Access Compliance Report

Public Rights-of-Way

(Curb Ramps)

Intersection ID: 10020275	Main Street: AYRSLEY_TOWN_BV	Cross Street: N/A	Location: N
ADA ID: E79B9E803A7C	Ramp Type: BlendTrans2	Initial Pass/Fail: Pass	Overall Compliance: No
			Severity Score: 5.25

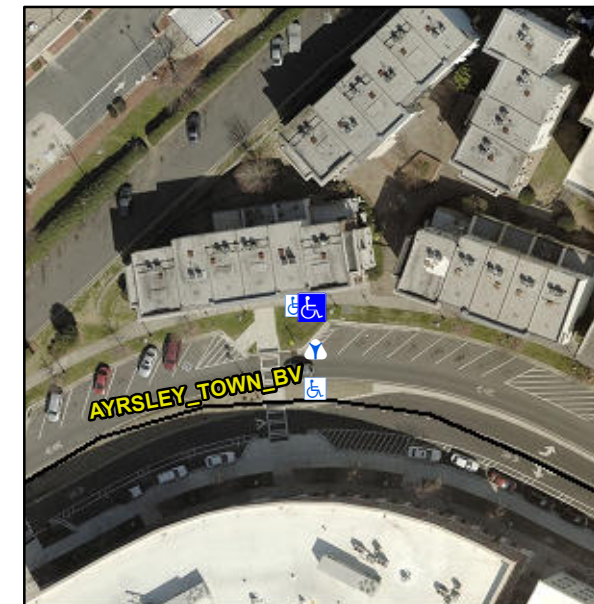
R304.5.3, R304.5.4

Remove & Replace Curb Ramp With Two New Directional Ramps or Equivalent. Remove & Replace Gutter.
